## Product Change Notice

Issue Date: 21-February-2022

NiPdAu pre-plated lead-frame

- AFBR-2555ARZ
- HFBR-2555AFZ
- AFBR-1555ARZ

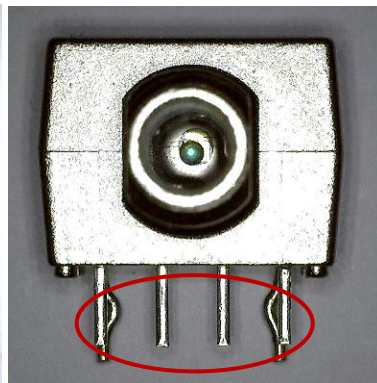
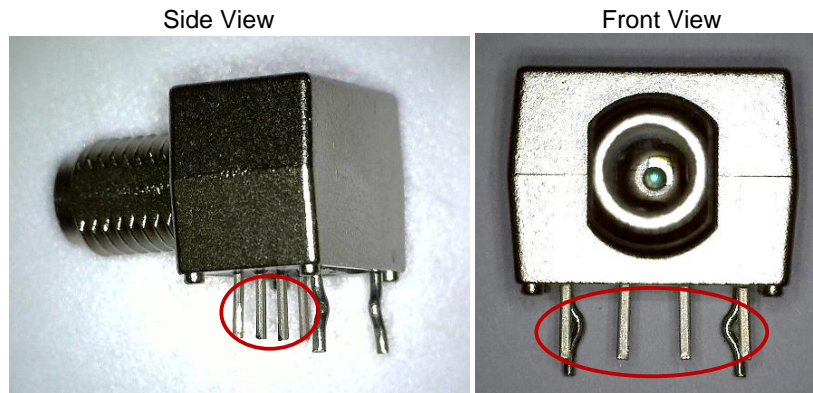
Qualify NiPdAu pre-plated lead-frame to adopt industry standard, improve product reliability, product cycle time and to simplify lead-frame supply chain.

Active pins (pin5, pin6, pin7 and pin8 in red circle): Affected by changing to new NiPdAu lead-frame finish.

Staple pins or Metal shield mounting pins (pin1, pin2, pin3 and pin4): No Change.
